SUPPLEMENTAL INSTRUCTION

PROJ.: Turnbull School
Music Room Addition
PROJ. No.: 1705
DATE: March 11, 2019
S.I. No. S.I. - 017

Vent Pipe Location

1 SI-017 VENT LOCATION
 SI-017.01 SCALE: 1 : 50

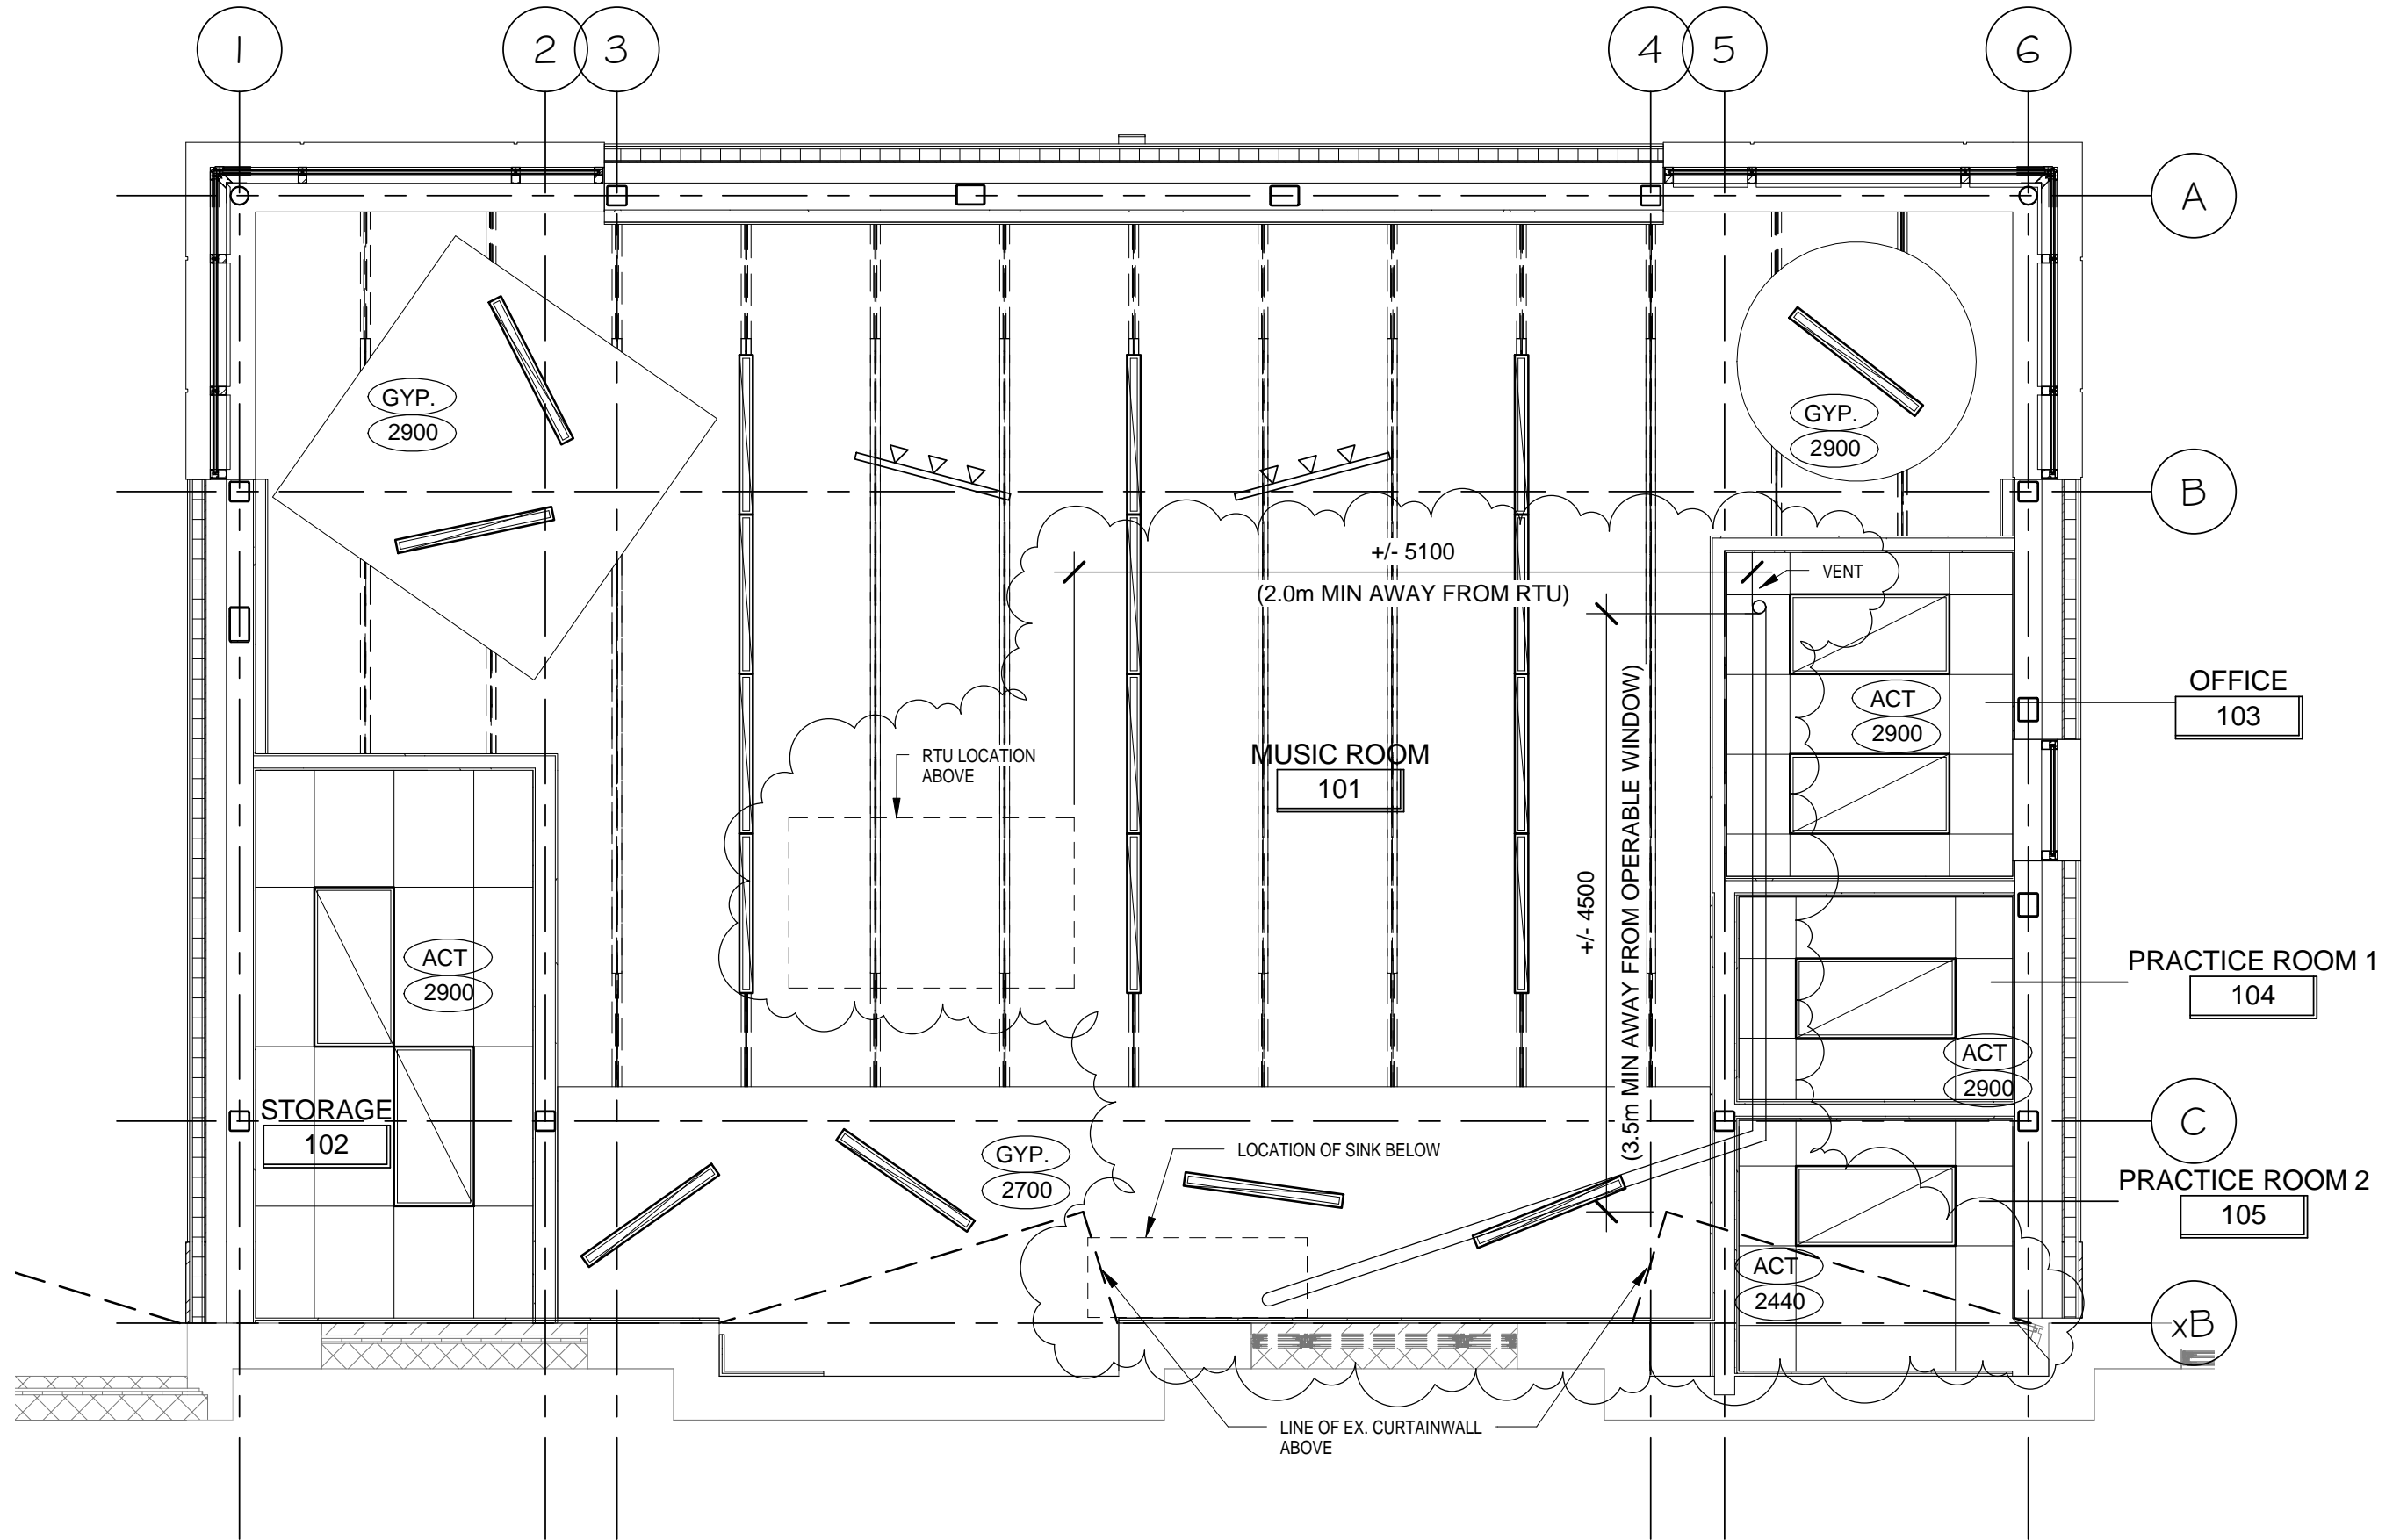
1. Refer to the attached Architectural Sketch SI-017.01 for location of the vent pipe. To be within bulkhead of the Music Room and ceilings of the Practice Rooms and Office. Vent out to be minimum 3.5 meters away from operable window and minimum 2.0 meters away from the RTU.
